CALL NO. 111
CONTRACT ID NO. 141211
ADDENDUM # 2

Subject: Christian County, NHPP 0411 (017)
Letting March 28, 2014

(1) Revised - Plan Sheets - R11, X13, X14, & X15

US 41A CROSS SECTIONS
STA. 42+50 TO STA. 43+00

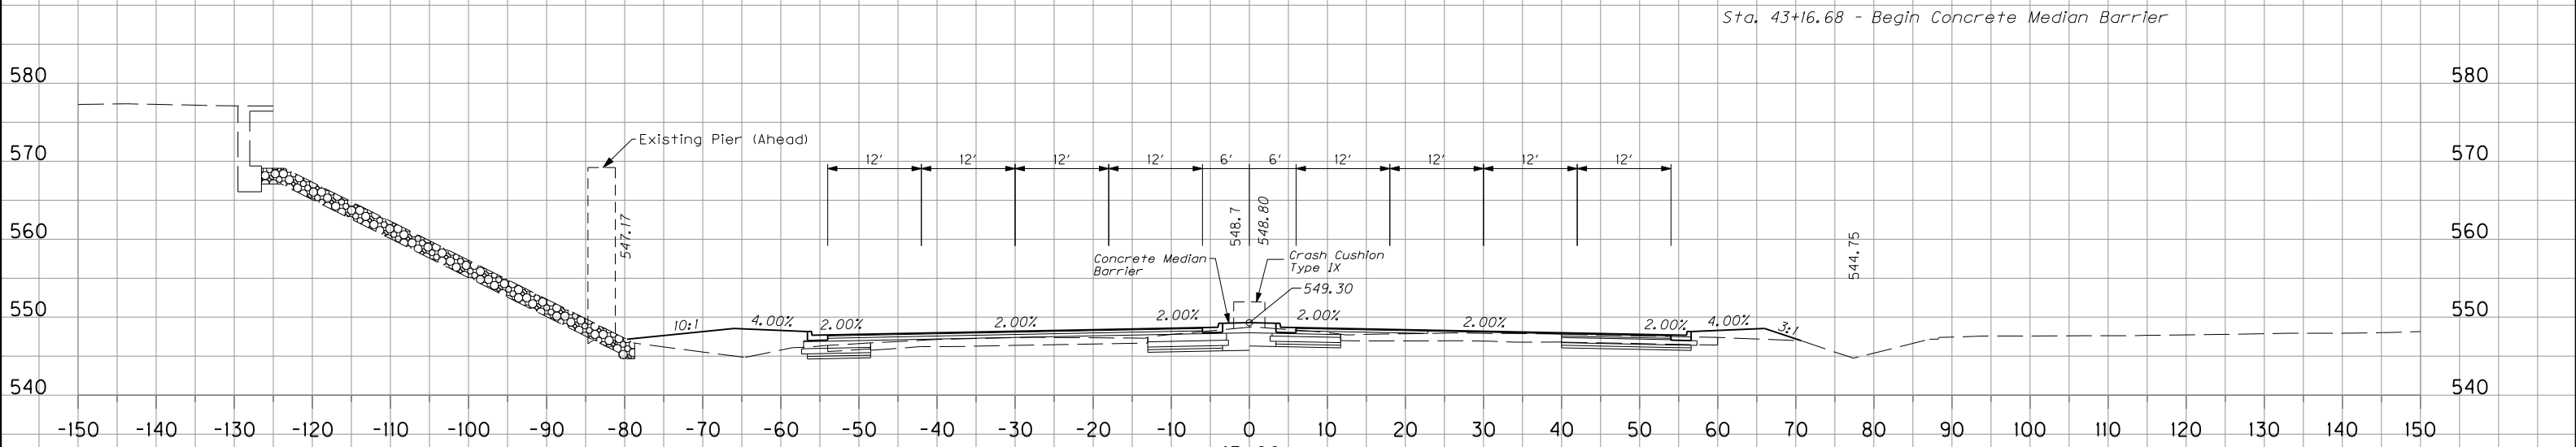
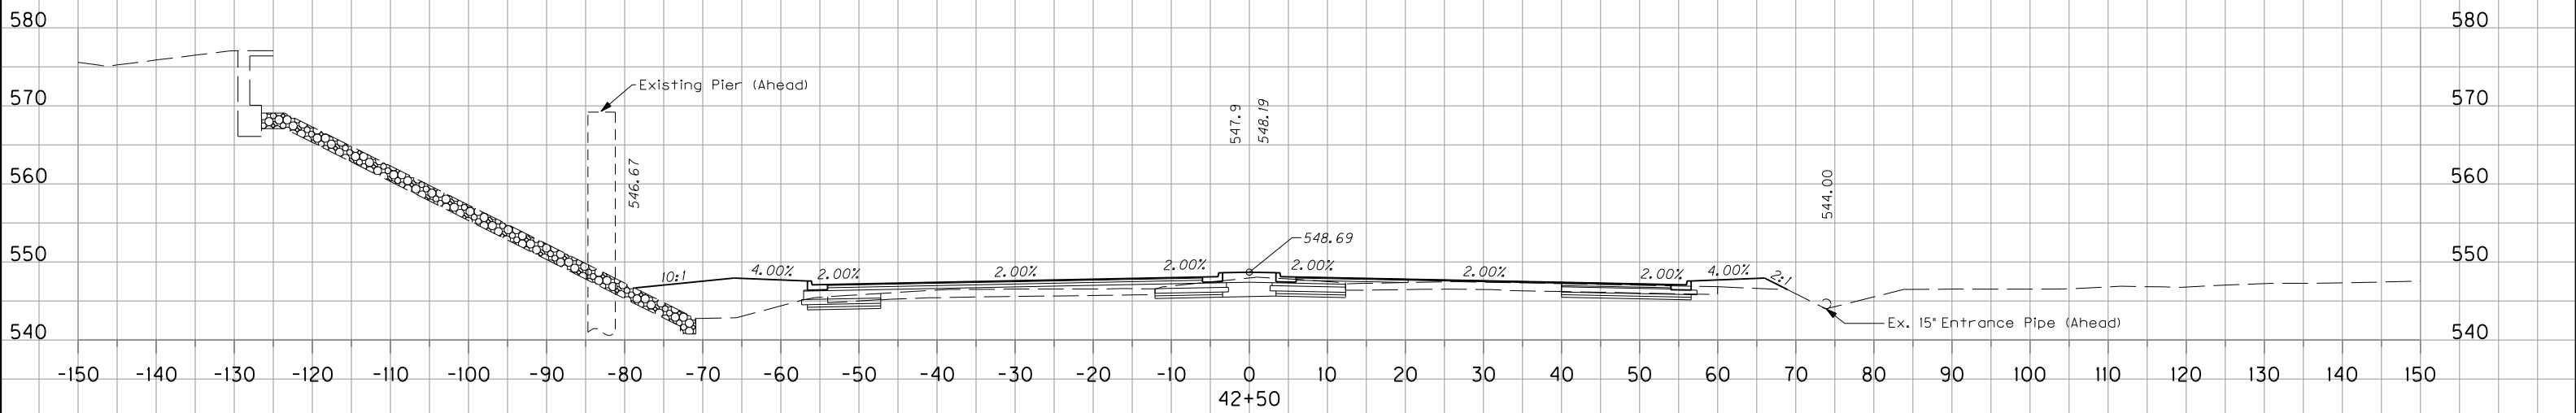
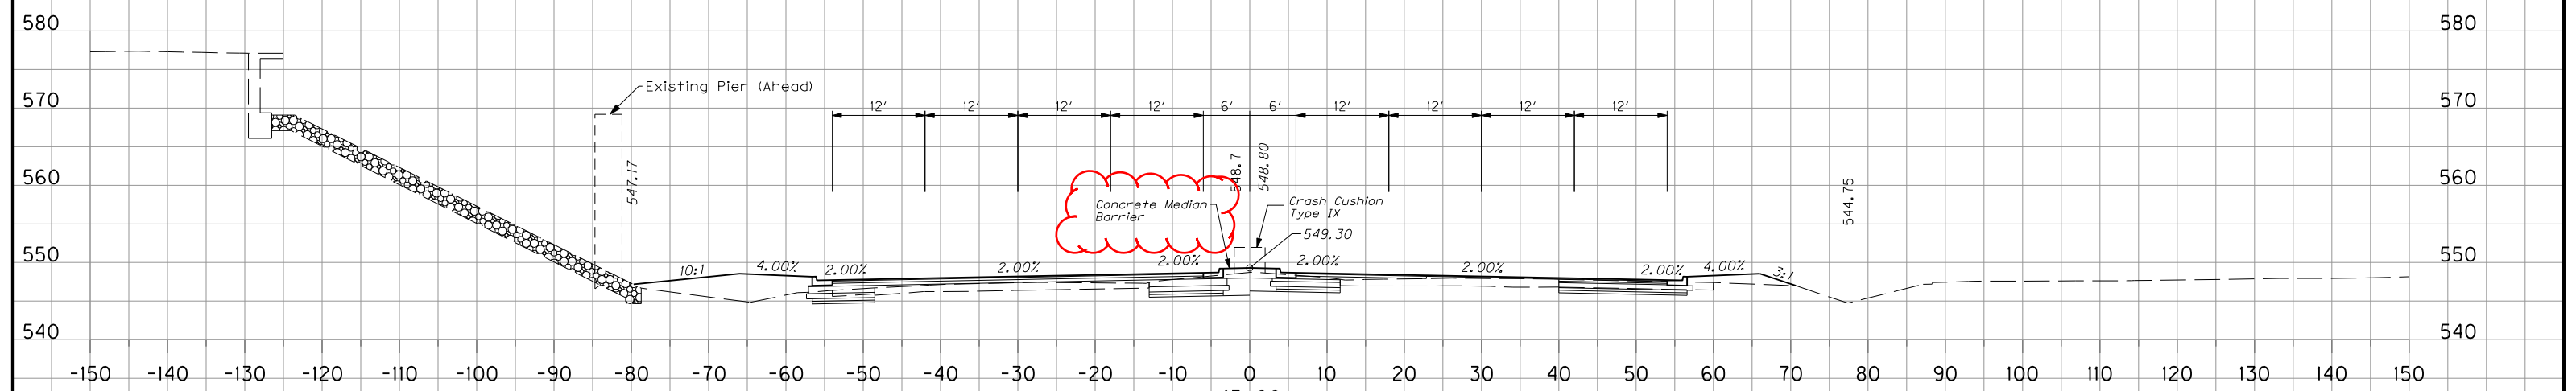
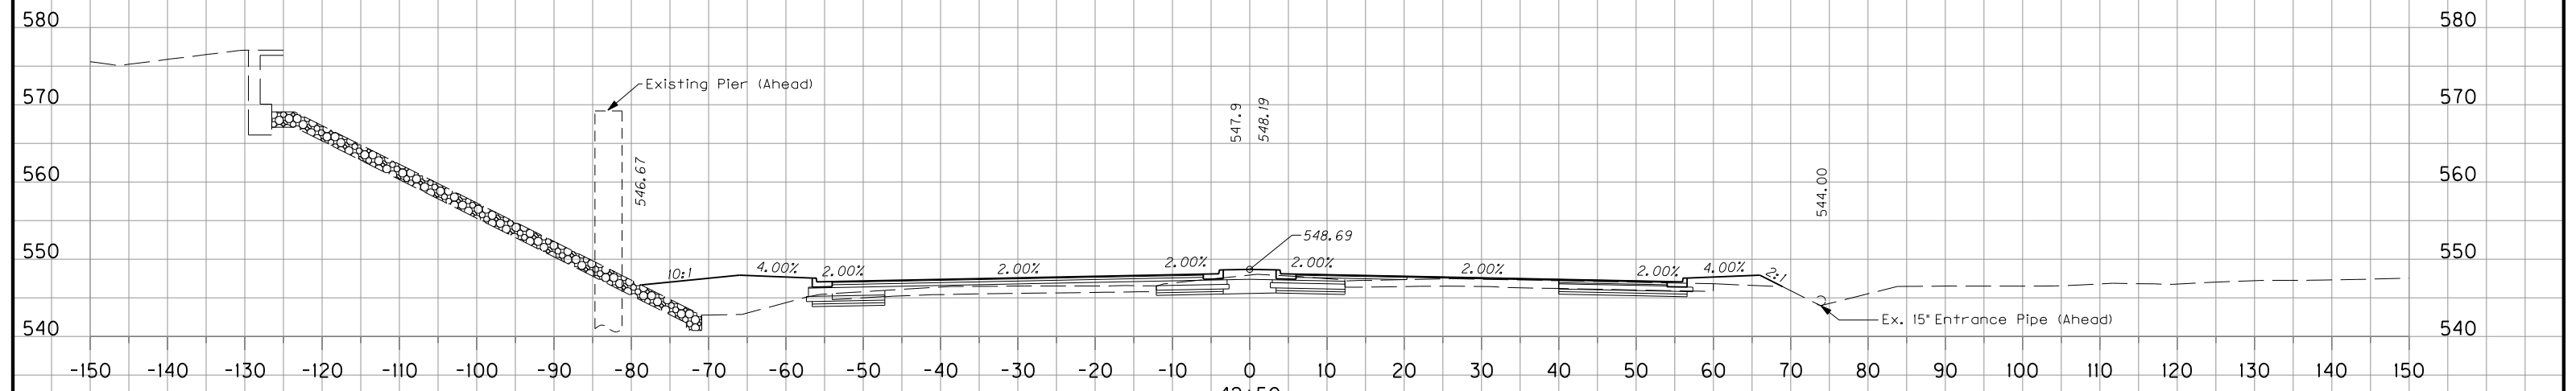
Removed Note

Sta. 43+16.68 - Begin Concrete Median Barrier

US 41A CROSS SECTIONS
 STA. 44+50 TO STA. 45+00

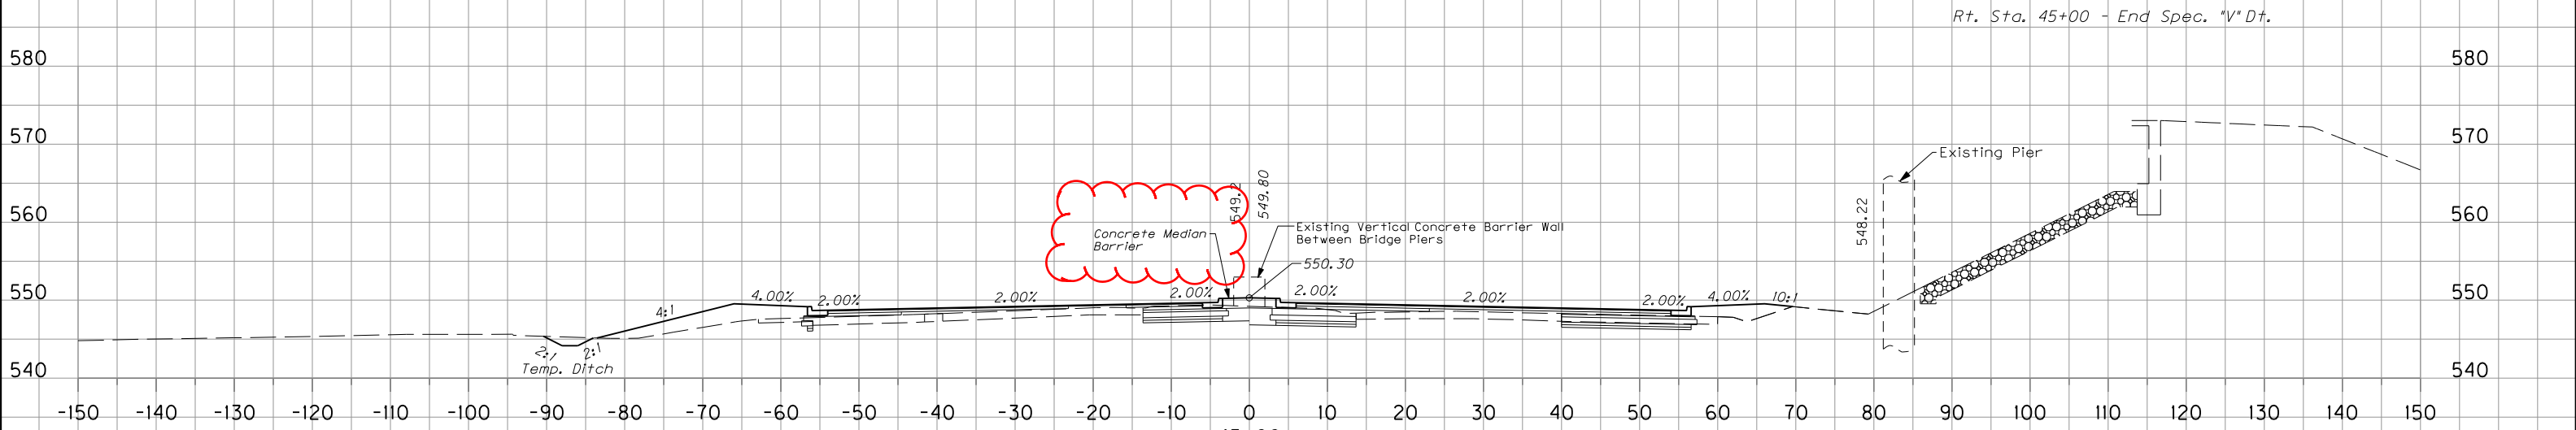
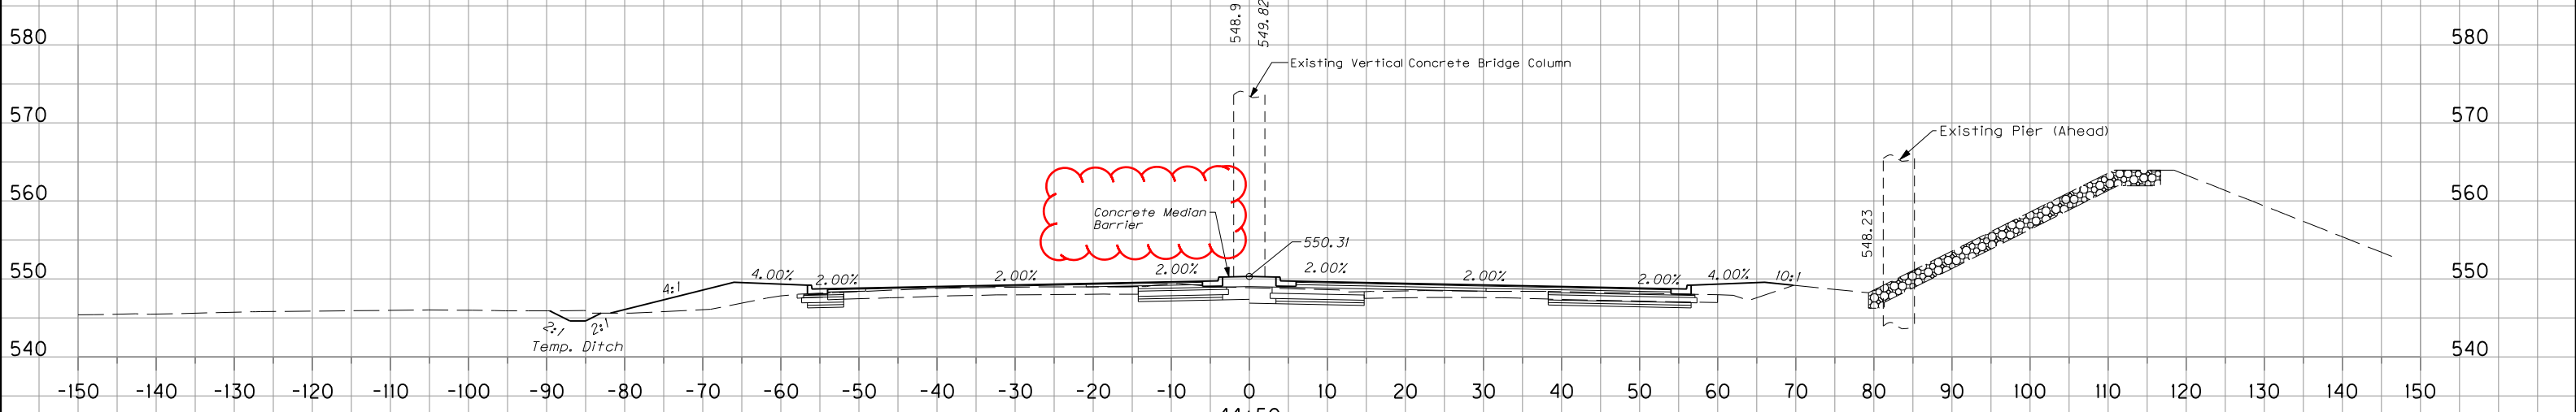
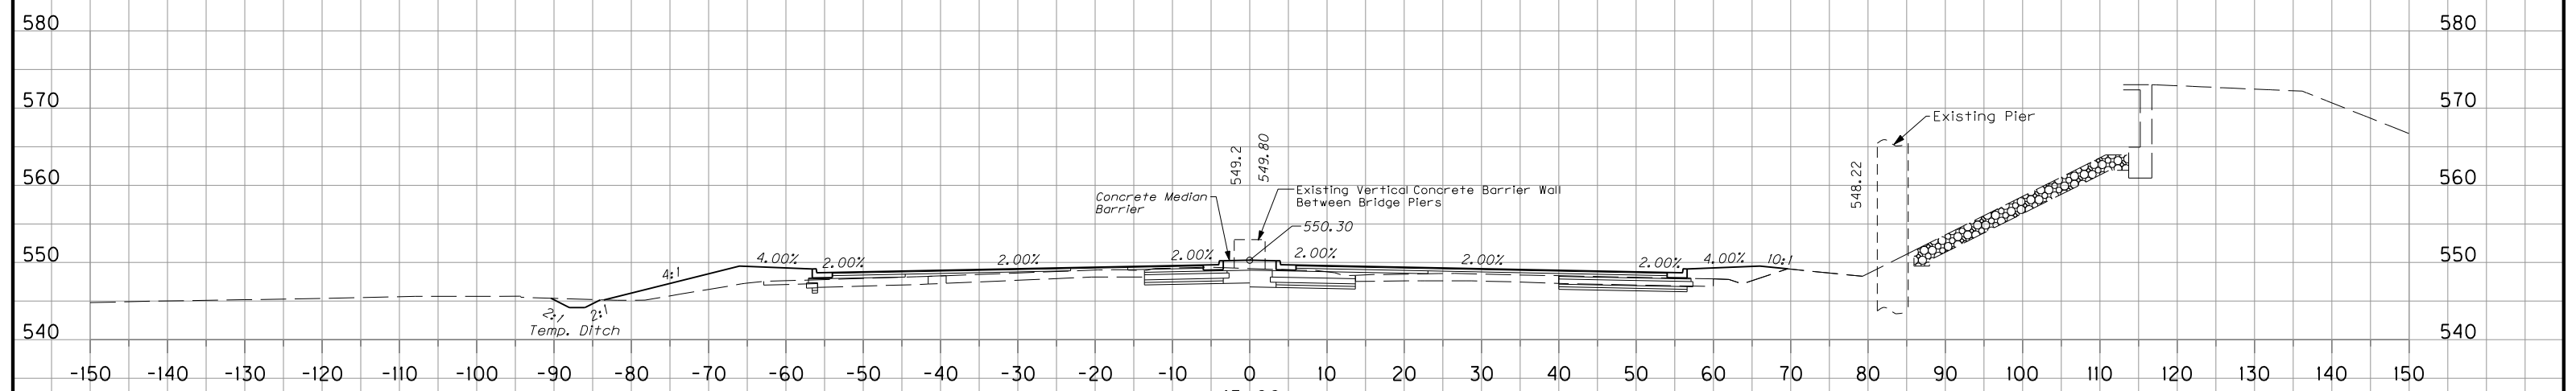
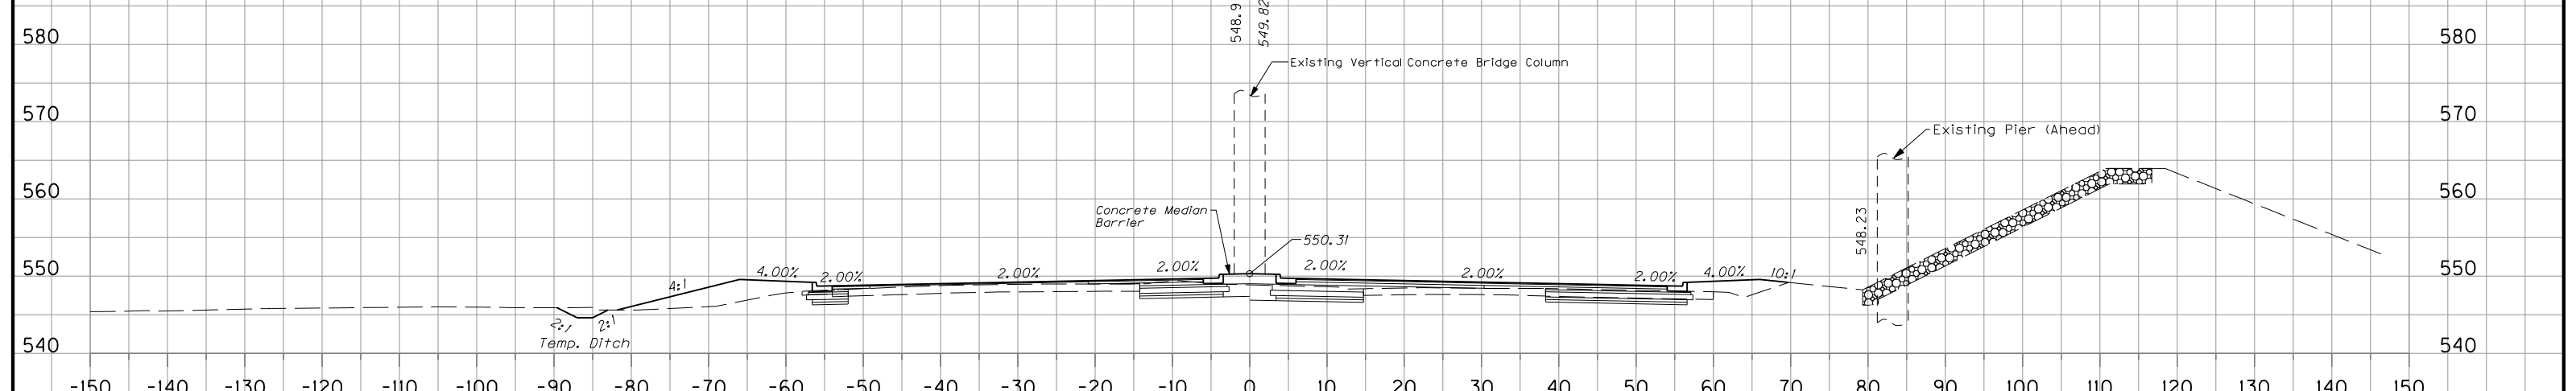
Removed Notes and added New Note
 Sta. 45+34.53 - End Concrete Median Barrier

Sta. 45+34.53 - End Concrete Median Barrier
